DEVELOPMENT NO.:	22007004
APPLICANT:	Luxury Lodge Group
NATURE OF DEVELOPMENT:	Tourist accommodation comprising 20 units with ancillary lodge and shop (personal services establishment in the form of a day spa), water tanks, access road and associated earthworks
ZONING INFORMATION:	Zones:  • Productive Rural Landscape  Overlays:  • Environment and Food Production Area  • Hazards (Bushfire - Medium Risk)  • Heritage Adjacency  • Hazards (Flooding - Evidence Required)  • Limited Land Division  • Mount Lofty Ranges Water Supply Catchment (Area 2)  • Native Vegetation  • Prescribed Water Resources Area  • Water Resources
LODGEMENT DATE:	9 March 2022
RELEVANT AUTHORITY:	Council Assessment Panel
PLANNING & DESIGN CODE VERSION:	2022.4 - 3 March 2022
CATEGORY OF DEVELOPMENT:	Code Assessed - Performance Assessed
NOTIFICATION:	Yes 09 February to 01 March 2023
RECOMMENDING OFFICER:	Brendan Fewster – Consultant Planner / James Booker Team Leader Statutory Planning

Image 2: Amended proposal

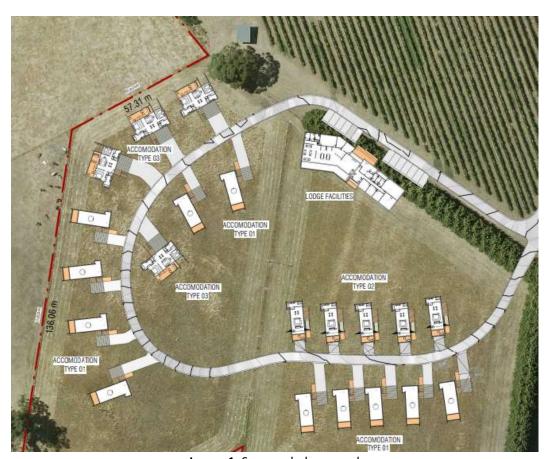
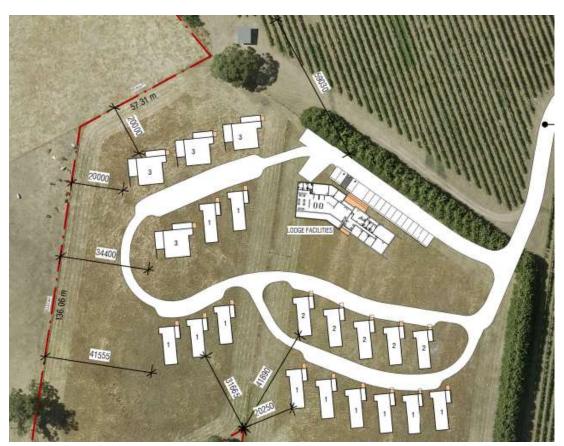
- The proposal has been varied since public notification as described below:
  - A reconfiguration of the accommodation units to achieve a minimum 20m setback from site boundaries;
  - Removal of access stairs for villas;
  - Removal of carports from villas as parking is to be accommodated within the road;
  - o Retention of existing pine trees adjacent to the proposed lodge building;
  - o Revised stormwater management plan; and
  - o Revised wastewater system.

Image 3 – Area of catchment which has not been addressed

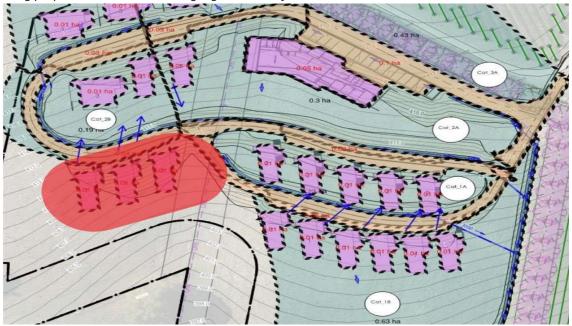
Council's Engineering Department reviewed the stormwater management plans submitted by the applicant. Council Engineering requested clarification on a number of matters, the majority of matters were resolved. Council Engineering are generally supportive of the overall scheme however stormwater calculations for one area of the site have not been satisfied. This matter remains outstanding and of concern to Council Engineering.

"I have reviewed the documents provided dated 28th May 2024 and have noted the previous request to review of missing catchment area below Cat\_2B has not been addressed. Please provide detailed calculations outlining the volume of stormwater runoff generated from this area and where it is to be directed without causing nuisance to neighbouring properties. Please see the highlighted area of concern."

Should the Panel be minded to approve the application, a Reserved Matter should be included to address the deficiencies with the civil stormwater design.
